Access Compliance Report

Public Rights-of-Way

Intersection ID: 13189	Main Street: HAWTHORNE_LN	Cross Street: SUNNYSIDE_AV	Location: SW
ADA ID: 6050959D89FD	Ramp Type: Perp	Initial Pass/Fail: Fail	Overall Compliance: No
		Severity Score: 25

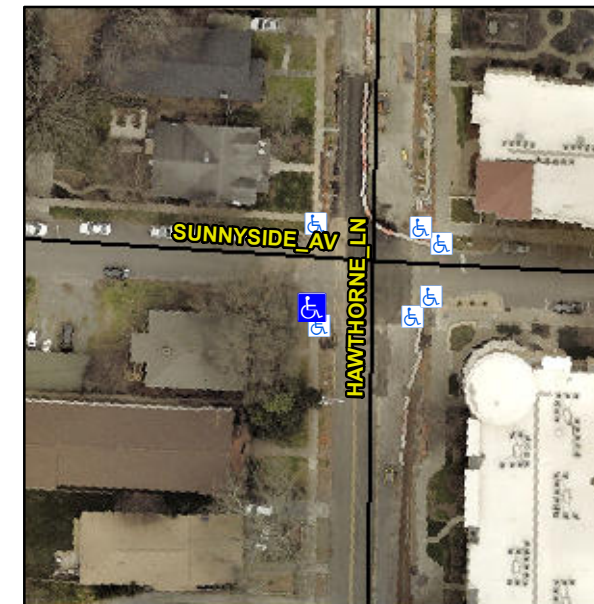
Not Found, R304.2.2, R304.5.3

Compliance	Description	Data	Compliance	Description	Data
N/A	Ramp Length (in)	40.0	No	Ramp Slope (%)	8.5
Yes	Ramp Width (in)	70.0	No	Ramp XSlope (%)	6.3
N/A	Flare Type LT	N/A	N/A	Flare Type RT	N/A
N/A	Flare Slope LT (%)	N/A	N/A	Flare Slope RT (%)	N/A
N/A	Flare Traversable LT?	N/A	N/A	Flare Traversable RT?	N/A
N/A	Landing Length (in)	N/A	N/A	DWS Provided?	N/A
N/A	Landing Width (in)	N/A	N/A	DWS Contrast?	N/A
N/A	Landing Slope (%)	N/A	N/A	DWS Length (in)	N/A
N/A	Landing X Slope (%)	N/A	N/A	DWS Full Width?	N/A
N/A	Landing Curb? (Y/N)	N/A	N/A	DWS Offset (in)	N/A
N/A	Shared Landing?	N/A			
N/A	Gutter Ponding?	N/A	N/A	Gutter Slope (%)	N/A
N/A	Gutter Lip Ht (in)	N/A	N/A	Gutter X Slope (%)	N/A
N/A	Painted X Walk1?	No	N/A	Painted X Walk2?	N/A
	X Walk 1 Direction	To N		X Walk 2 Direction	N/A
N/A	X Walk 1 Width (in)	N/A	N/A	X Walk 2 Width (in)	N/A
	X Walk 1 Slope (%)	0.7		X Walk 2 Slope (%)	N/A
	X Walk 1 X Slope (%)	3.1		X Walk 2 X Slope (%)	N/A

Remove & Replace Entire Ramp.
